CONSUMERS POWER COMPANY
Docket 50-155
Request for Change to the Technical Specifications
License DPR-6

For the reasons hereinafter set forth, it is requested that the Technical Specifications contained in the Facility Operating License DPR-6, Docket 50-155, issued to Consumers Power Company on May 1, 1964, for the Big Rock Point Plant be changed as described in Section I below:

FIGURE 1

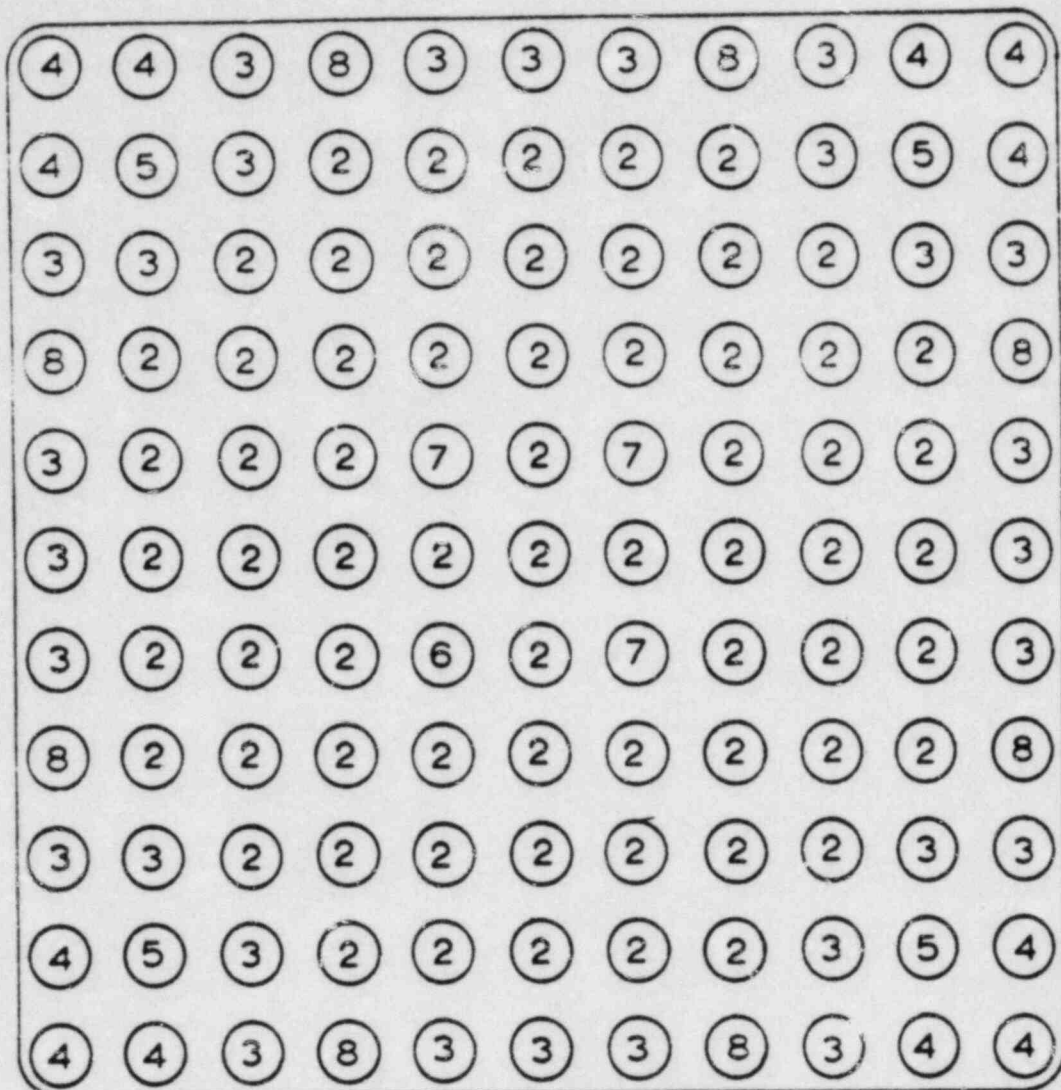
Reload H-3 fuel design is show in Figure 1 (attached). The differences between H-3 and H-2 are:

1. In Reload H-3 the gadolinia rods are moved closer to the periphery of the fuel bundles and
2. The gadolinia content of the gadolinia bearing fuel rods is higher (2.0 w/o Gd_2O_3) for H-3 as compared to H-2 (1.5 w/o Gd_2O_3).

These minor differences have no effect on the thermal hydraulic design basis for ENC Fuel. The changes in fuel design have been made to provide an improved shut-down margin at the beginning of core life.

A slight increase in local peaking factors, results in higher peak clad temperatures for the H-3 reload in comparison to the H-2 reload at low burnups. The H-3 MAPLHGRs were reduced at lower exposures to assure peak clad temperatures less than 2200°F. The MAPLHGRs for the H-3 reload were decreased from the previous H-2 reload values at low bundle burnups (below 6.62 GWD/STM). At higher burnups, the MAPLHGR values for the ENC H-3 design are identical to those for the H-2 reload. These effects are illustrated by comparing the last two columns of the proposed Table 2 of the Technical Specification Section 5.2.1(b).
